Addendum #: Addendum #4
Issue Date: 04/08/2024

The following additions, clarifications and revisions have been made to the Contract Documents:

Job #: 8-22-01-011 Edgar County Jail
 TBD SPRINGFIELD RD
 PARIS, Illinois 61944

PROJECT NO. 22-4048
 DRAWING ISSUED DATE: 03/01/2024
SHEET S201

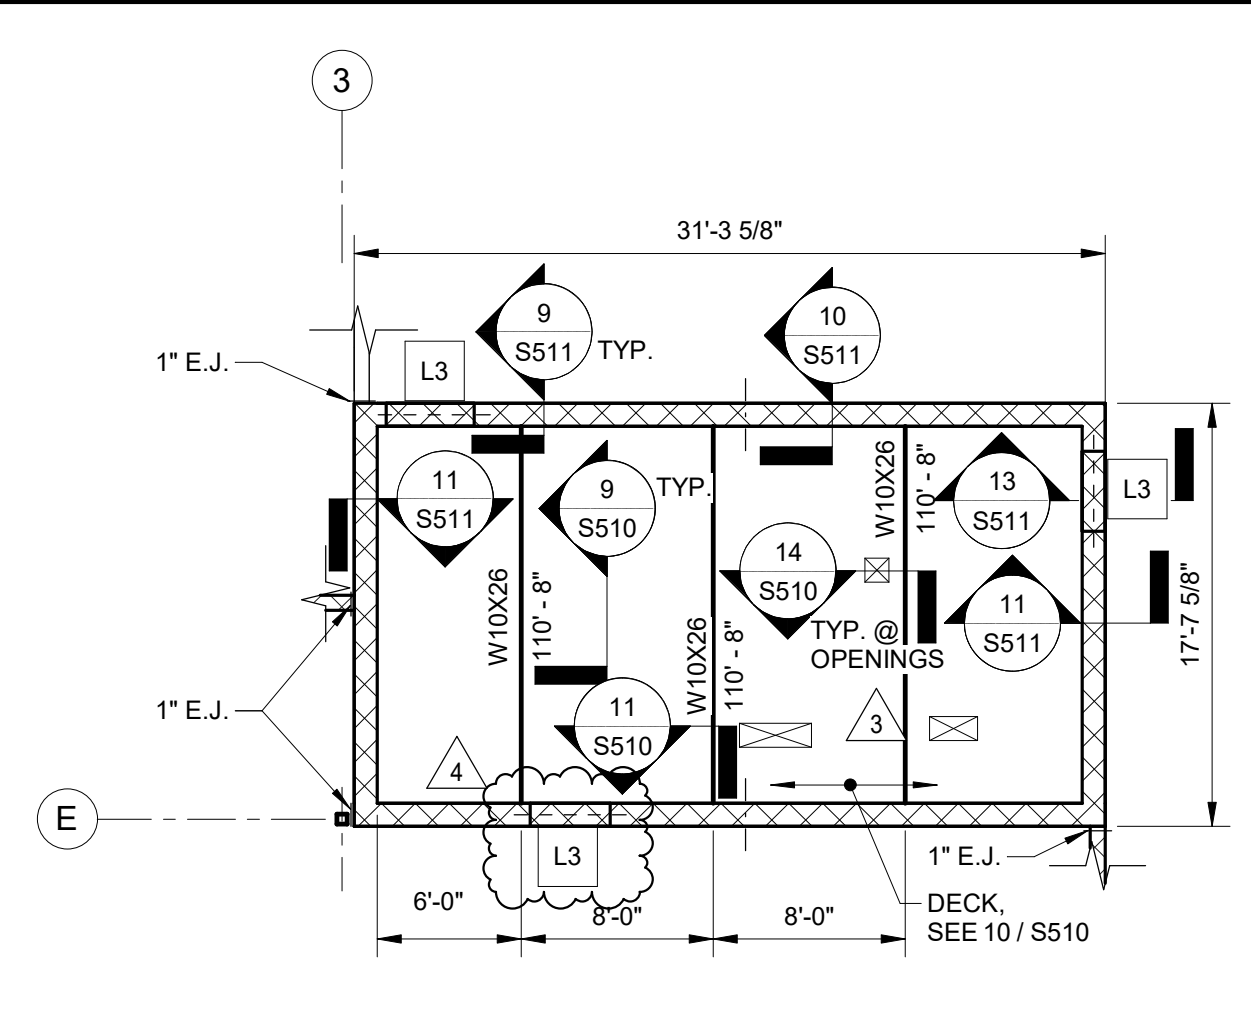
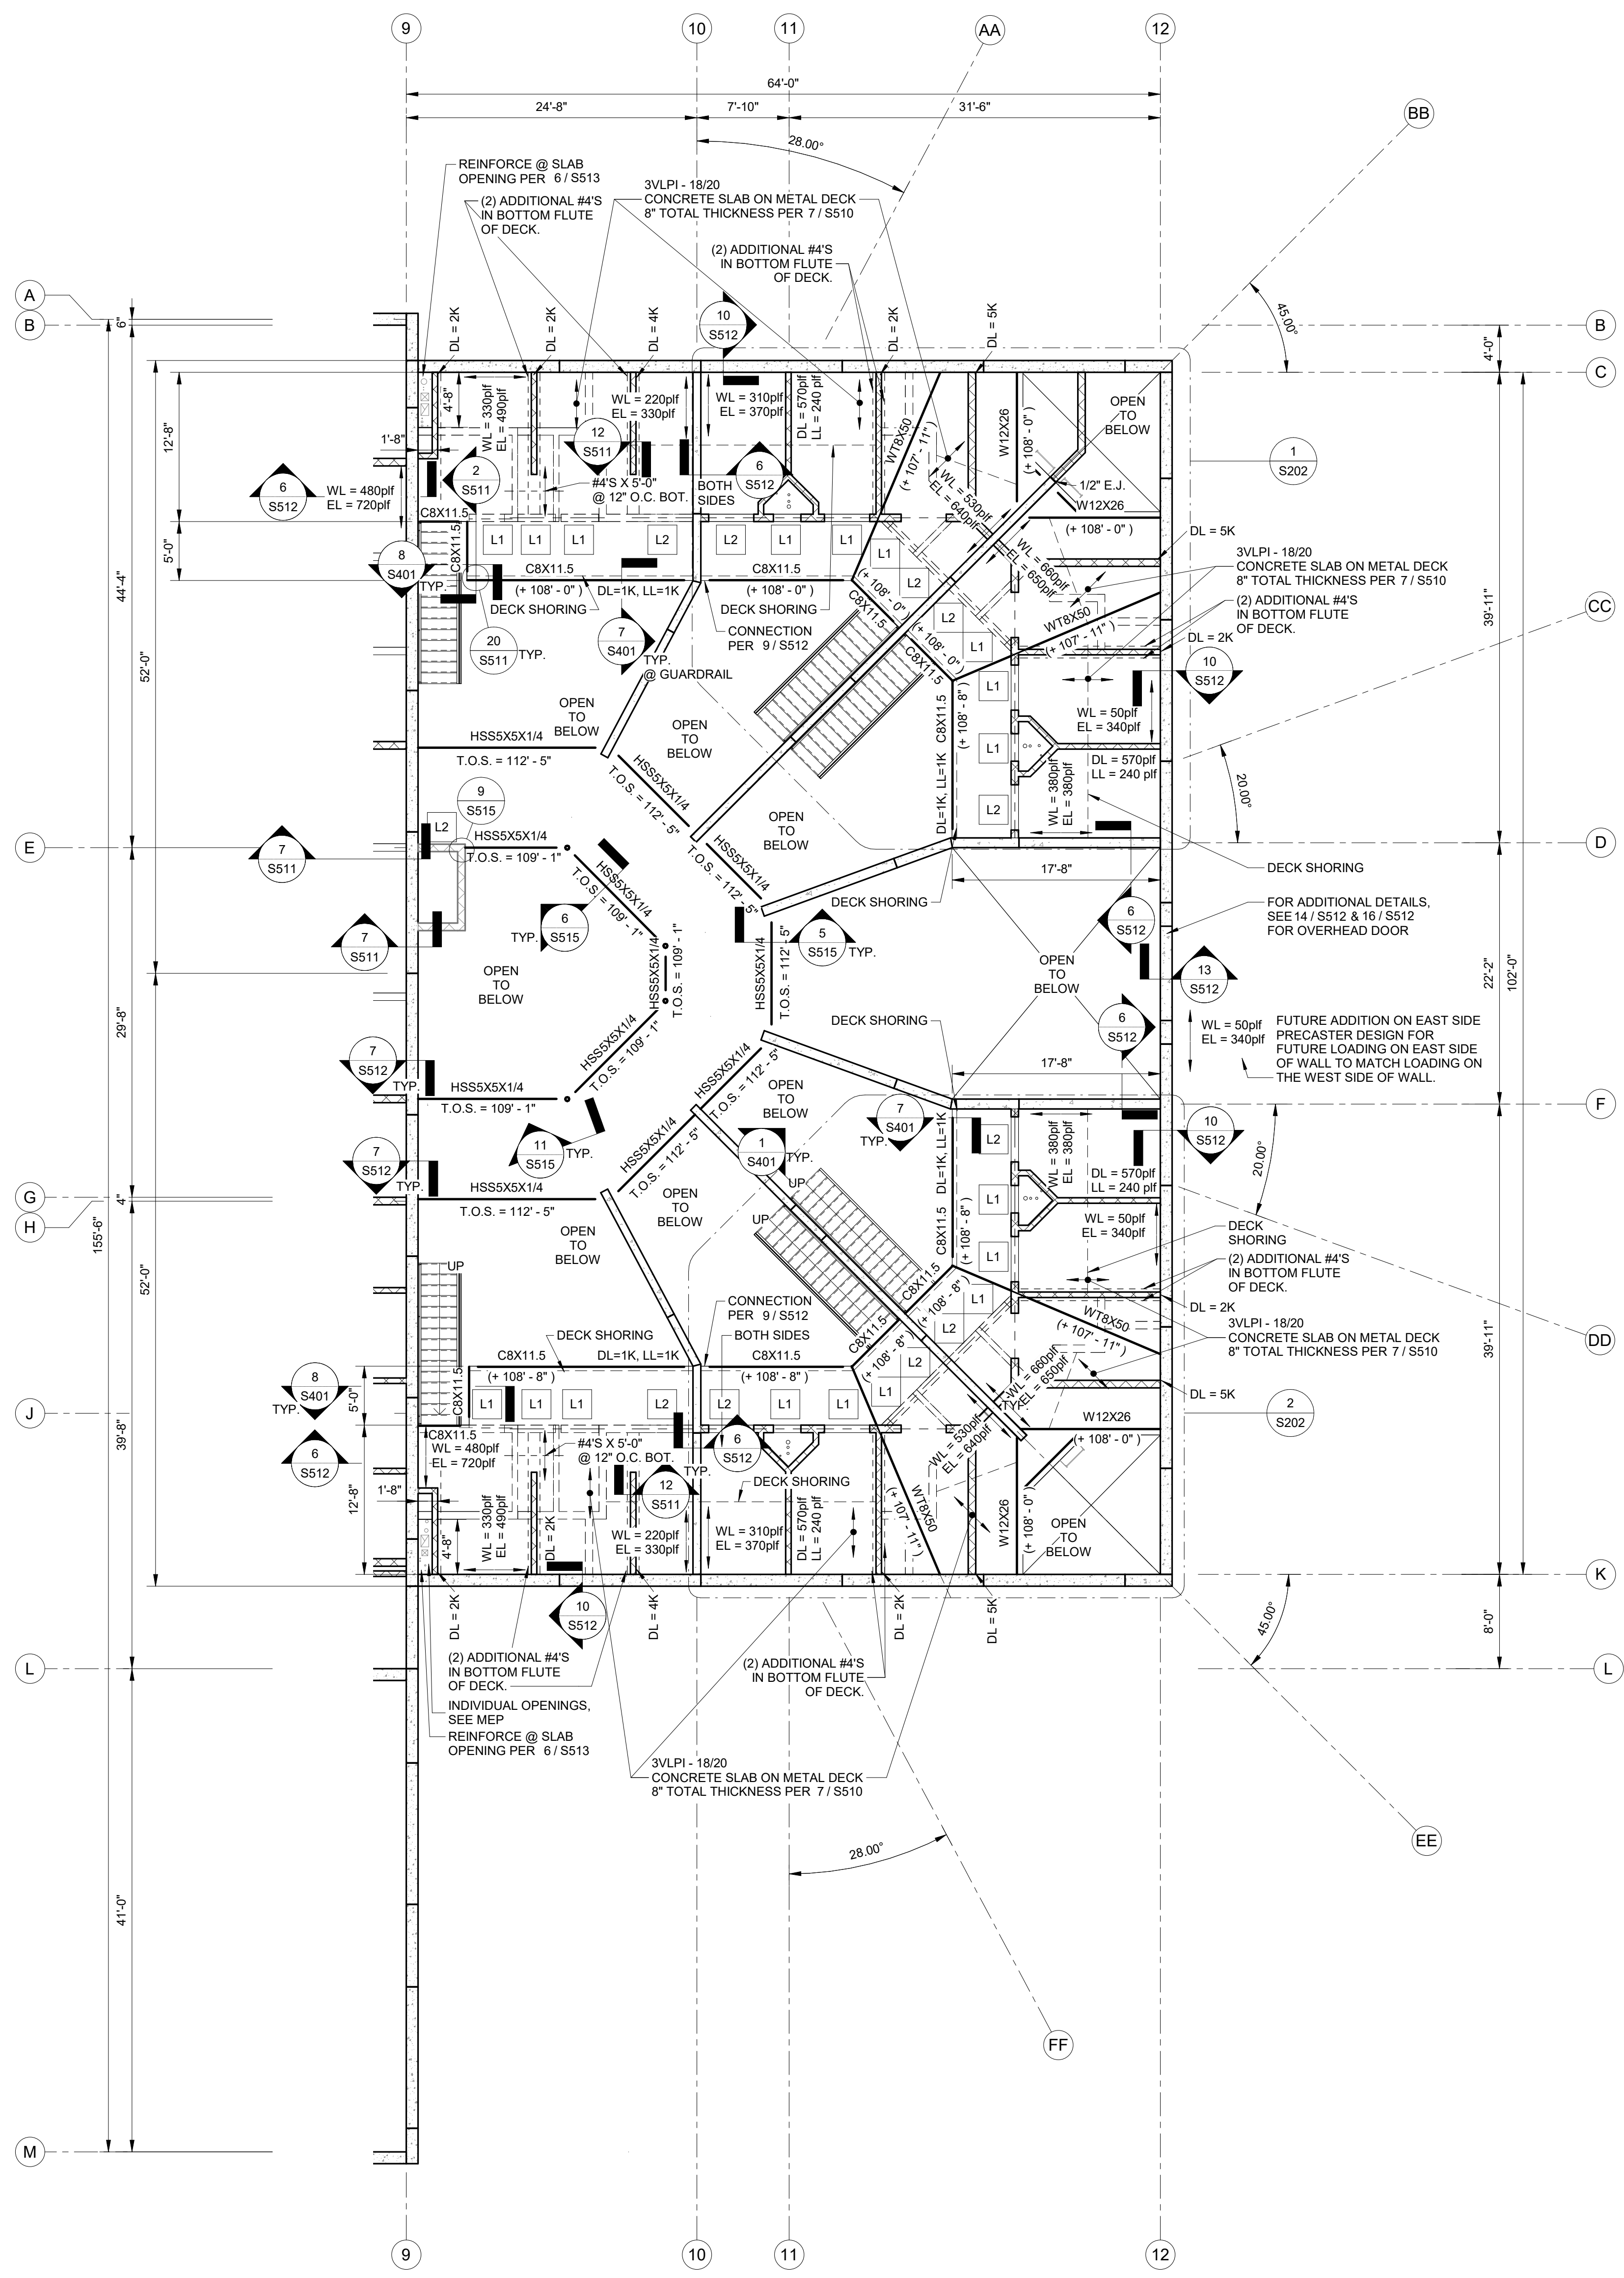
22	S102	REVISED as clouded on Sheet S102
23	S201	REVISED as clouded on Sheet S201
24	S511	REVISED as clouded on Sheet S511
25	S502/S503	CLARIFY: Titles have been revised as shown clouded on the drawing attached to clarify where the details are to be used. The thickened slab footings with top of footings at elevation 100'-0" are intended to be placed with the floor slab, but means and methods of construction will be determined by the Contractor if additional construction joints are necessary. The floor slopes, recessed floors, and drains need to be accommodated as shown on the Architectural, Structural, and/or Plumbing drawings.
26	FP 101 Fire Protection First Floor	CLARIFY: Scope TBD by CM but VESDA system, Detectors, and wiring are all required for proper operation.
27	M101.B HVAC Firest Floor Plan- Area B	CLARIFY: It is acceptable to install the temperature and humidity sensors in the return duct. The setpoints shall be adjustable through the graphics.
